Moisture Assessment Report

2629 Westgate Street, Unit A

Summary Page

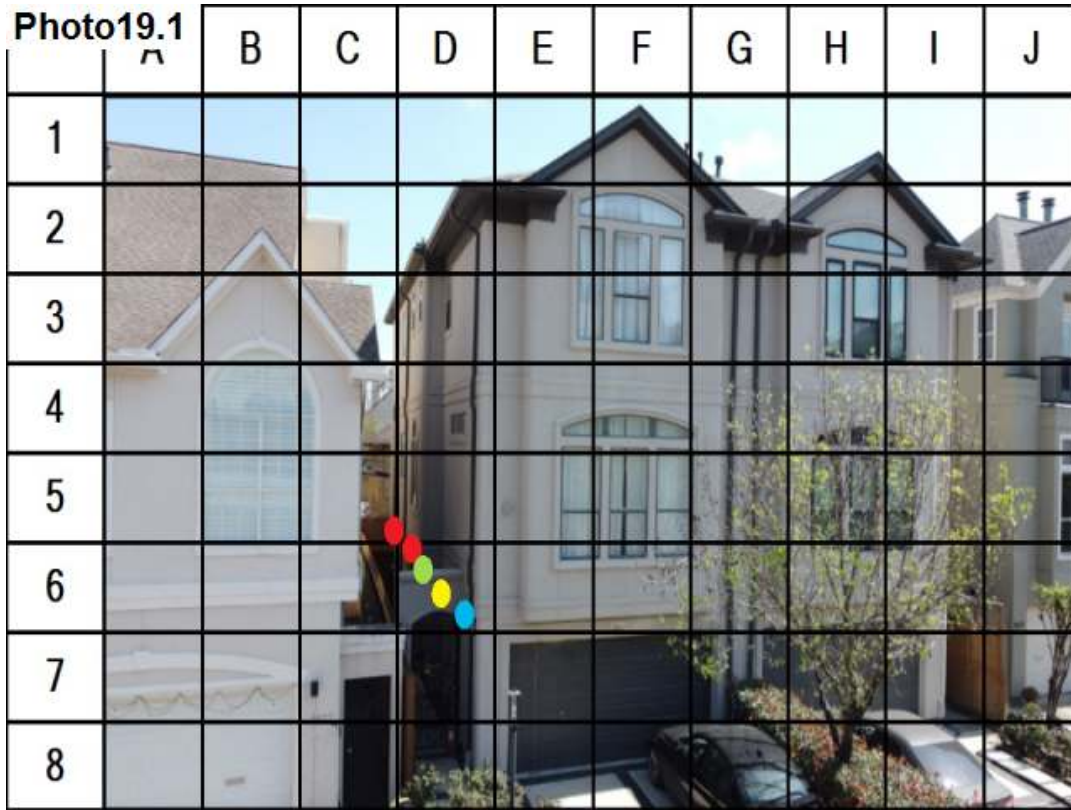
Grid Location	Item Description	Moisture Readings	Substrate Condition	Observations
C5	Bottom Wall	36%	Semi-Soft	A moisture probe was taken at the bottom wall below the windows. An elevated moisture reading with semi-soft substrate was noted. It is suggested by the inspector to consult with a waterproofing contractor to core sample and modify this area as needed.
D6 Red	Bottom Wall	24%	Semi-Firm	A moisture probe was taken at the bottom wall below the windows. An elevated moisture reading was noted with a semi-firm substrate.
D6 Green	Bottom Wall	12%	Firm	A moisture probe was taken at the bottom wall below the windows. The substrate was firm with no damage noted at this time.
D6 Yellow	Bottom Wall	12%	Firm	A moisture probe was taken at the bottom wall below the windows. The substrate was firm with no damage noted at this time.
D6 Blue	Bottom Wall	12%	Firm	A moisture probe was taken at the bottom wall below the windows. The substrate was firm with no damage noted at this time.

All damaged substrate was replaced and a relief was added.

Photo20.6

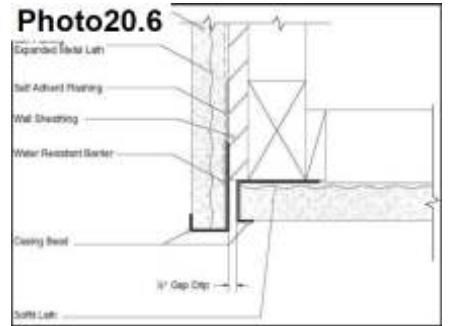
Grid Location	Item Description	Moisture Readings	Substrate Condition	Observations
Red Box	Potential Damage			Soft substrate is noted at the bottom of the wall below the bank of windows. The inspector recommends having a qualified waterproofing contractor core sample to further assess the extent, then repair if needed and install a proper relief in an effort to prevent moisture intrusion. Please refer to photos #20.2, #20.3, #20.4, #20.5 and #20.6 for more detail.

All damage substrate was replaced and a relief was added.

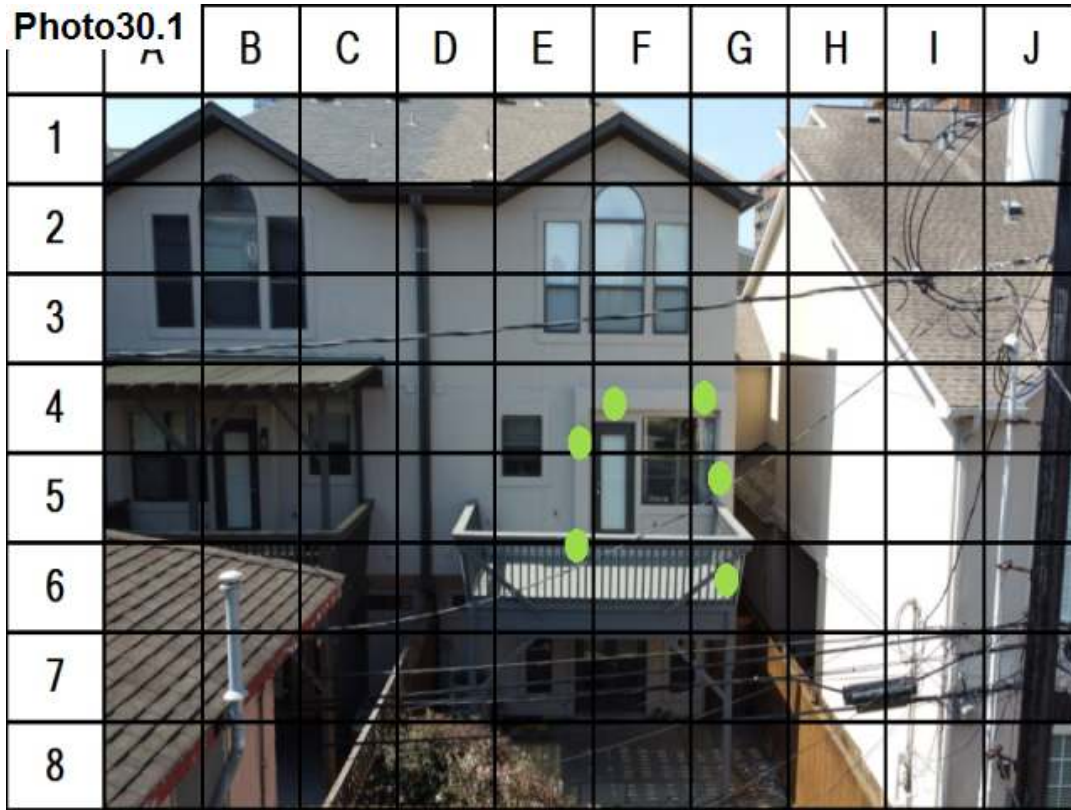
Grid Location	Item Description	Moisture Readings	Substrate Condition	Observations
E6	Below Flat Accent	12%	Firm	A moisture probe was taken below the flat accent. The substrate was firm with no damage noted at this time
E4	Below Flat Accent	13%	Firm	A moisture probe was taken below the flat accent. The substrate was firm with no damage noted at this time
F4	Below Flat Accent	16%	Firm	A moisture probe was taken below the flat accent. The substrate was firm with no damage noted at this time
G4	Below Flat Accent	17%	Firm	A moisture probe was taken below the flat accent. The substrate was firm with no damage noted at this time
G5	Below Flat Accent	12%	Firm	A moisture probe was taken below the flat accent. The substrate was firm with no damage noted at this time
G6	Below Flat Accent	12%	Firm	A moisture probe was taken below the flat accent. The substrate was firm with no damage noted at this time

The flat accent area was painted 3 times with an elastomeric paint.

Photo31.1

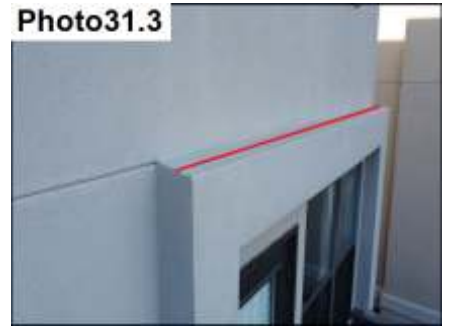
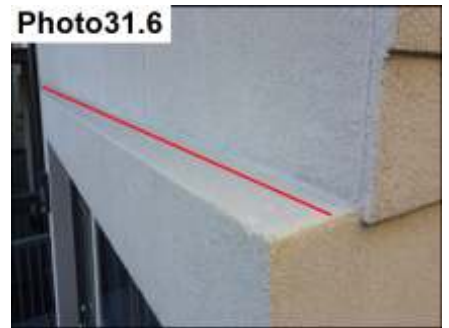
Grid Location	Item Description	Moisture Readings	Substrate Condition	Observations
Red Line	Flat Accent			A flat accent has been noted in this area. Although the moisture levels were acceptable the inspector suggests to have a waterproofing contractor further assess and to apply elastomeric coating or install a metal cap as needed, in an effort to prevent moisture intrusion. Please refer to photos #31.2, #21.3, #31.4, #31.5 and #31.6 for more detail.

The noted flat accent area was painted 3 times with an elastomeric paint.

Photo32.4

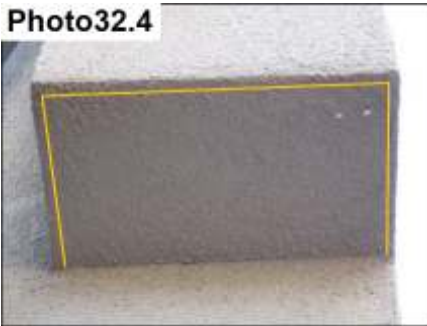
Grid Location	Item Description	Moisture Readings	Substrate Condition	Observations
Orange Line	Relief			Although the bottom of the wall noted does not have a proper relief, this was a proper detail at the time of construction. Upon invasive testing at this location, the substrate was firm with low moisture readings. The inspector recommends no modification at this point in time but recommends to maintain all sealants above this location to prevent potential moisture intrusion. Please refer to photos #32.2, #32.3 and #32.4 for more detail.

A relief has been added.

Photo33.4

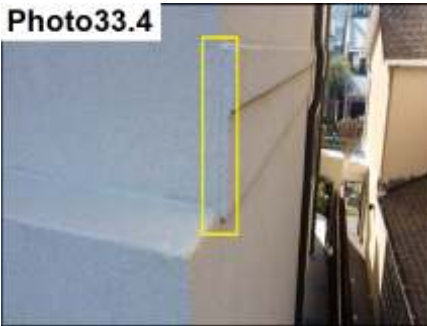
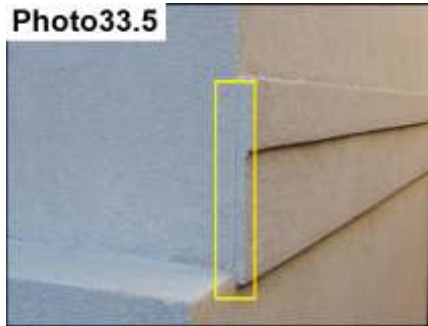
Grid Location	Item Description	Moisture Readings	Substrate Condition	Observations
Yellow Box	Cracks			Cracks are noted at the stucco accent and stucco termination this location. The inspector suggests to have a qualified waterproofing contractor seal or paint for aesthetic concerns only. All cracking was not necessarily identified in this report. Please refer to photos #33.2, #33.3, #33.4 and #33.5 for more detail.

All noted cracks have been caulked/sealed.
